April 11, 2025

ADDENDUM No. 2

PROJECT: **Bid 2900-0525 - 2025 FAIRMONT SANITARY SEWER REHABILITATION PROGRAM**

SUMMARY OF QUANTITIES

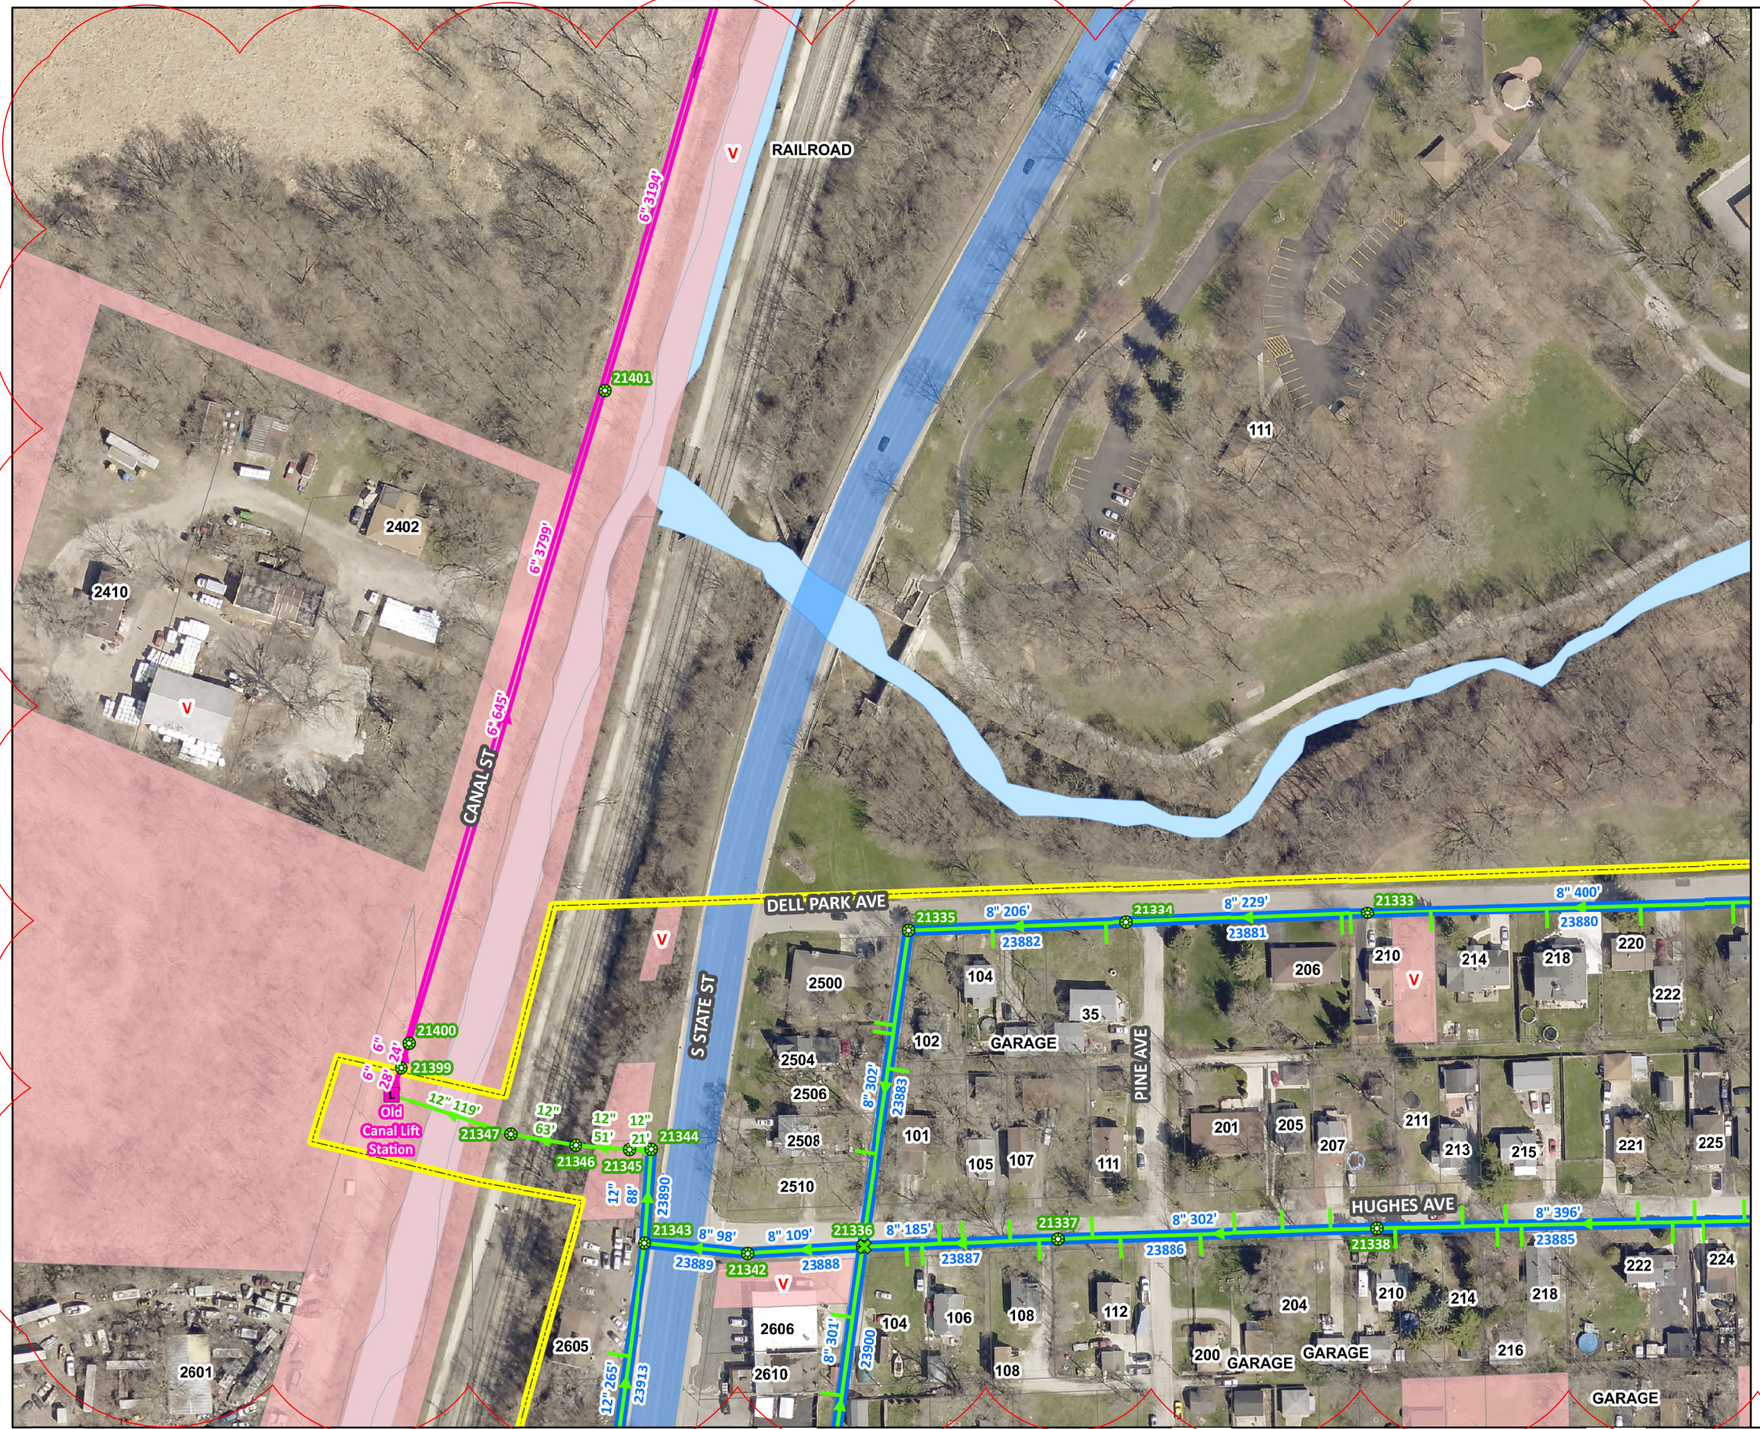
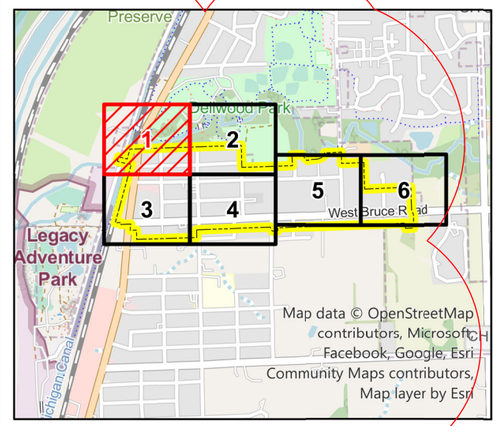
2. **SUMMARY OF QUANTITIES**

DELETE the SUMMARY OF QUANTITIES in its entirety (1 sheet).

INSERT the revised SUMMARY OF QUANTITIES (1 sheet).

ITEM NO.	ITEM DESCRIPTION	UNITS	TOTAL QUANTITY
BID CONTINUED			
23	Cementitious Manhole Sealing, 36" Dia.	VF	14
24	Cementitious Manhole Sealing, 48" Dia.	VF	100
25	Vacuum Testing	EACH	3
26	Repair Bench & Trough	EACH	1
27	Replace Bench & Trough	EACH	1
28	Pour Bench	EACH	5
29	Plug Pipe with Mechanical Plug and Concrete Cap	EACH	3
30	HMA Driveway Pavement Removal and Replacement	SY	20
31	PCC Driveway Pavement Removal and Replacement	SY	20
32	Contingent Cash Allowance	LS	1

CANAL SEWER AS-BUILTS

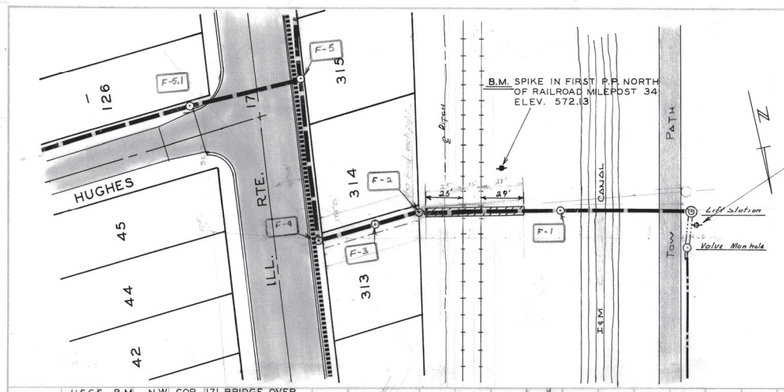
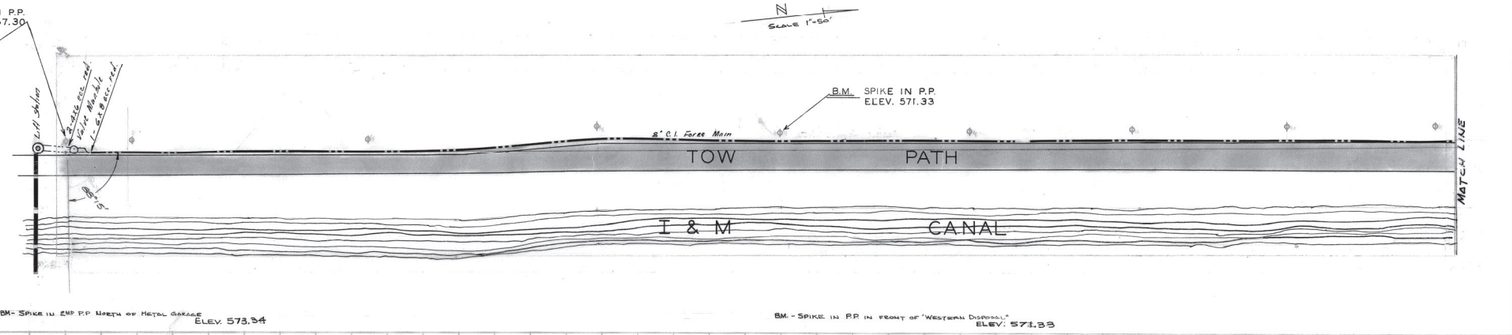
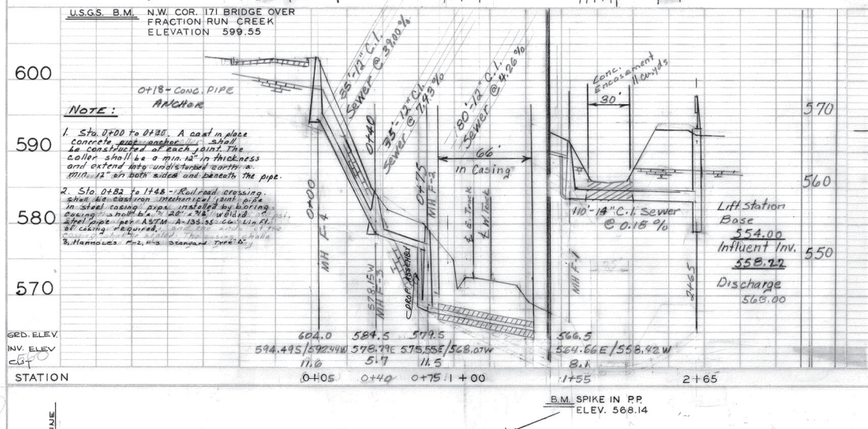
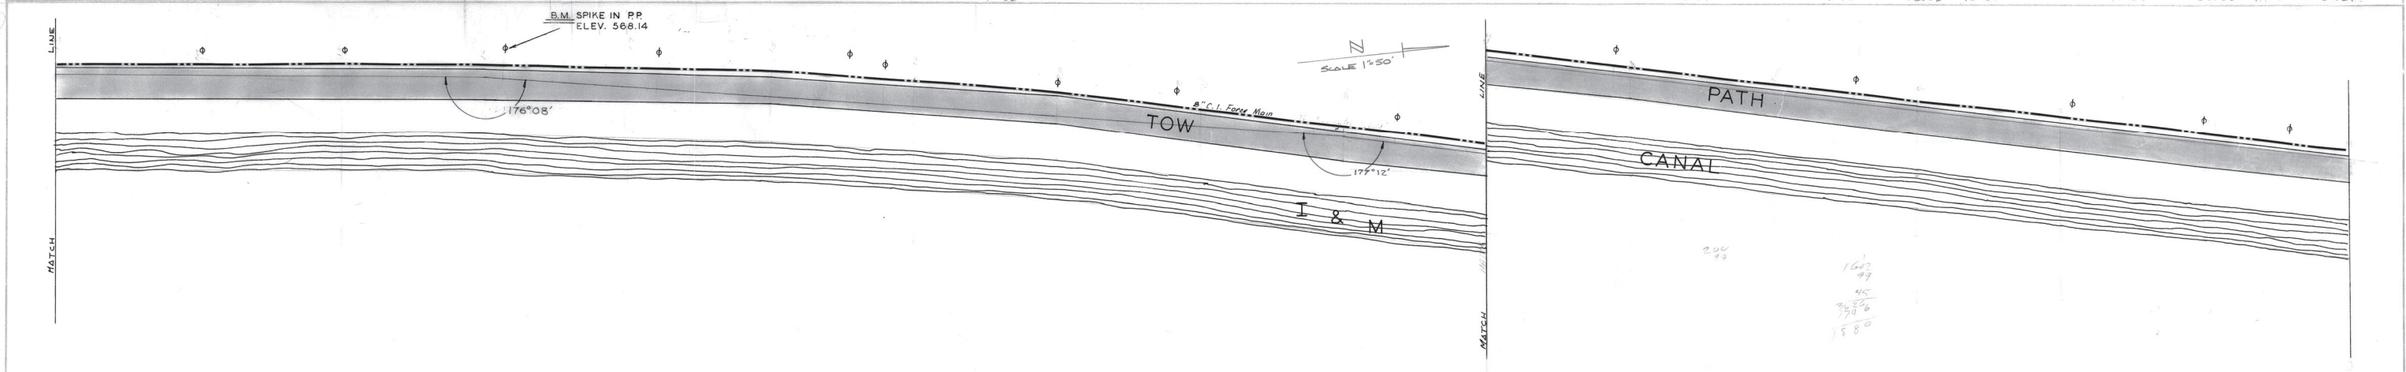
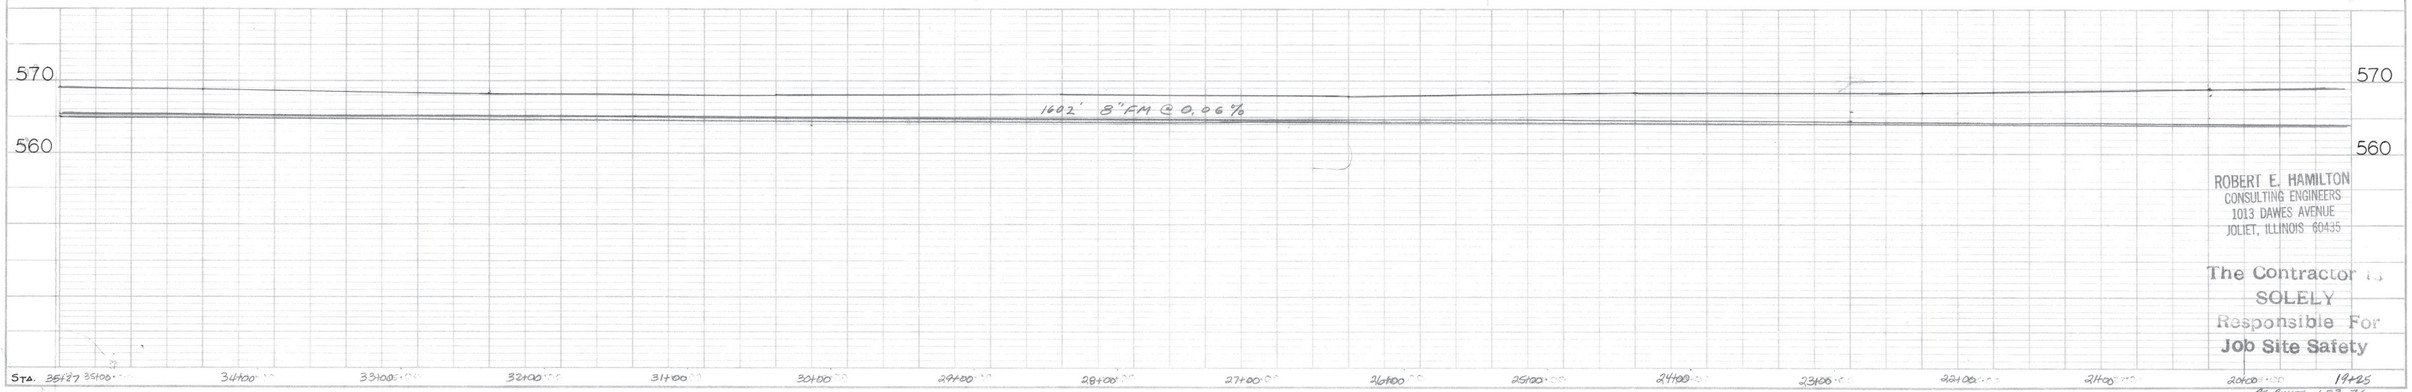
Q: Can the City provide depth data on the line going under the tracks. Do we have an understanding of how deep or what shape it takes?

A: CIPP lining of this segment has been removed from the scope and the information is not needed. However, an As-built of the area has been attached in Appendix D for reference.
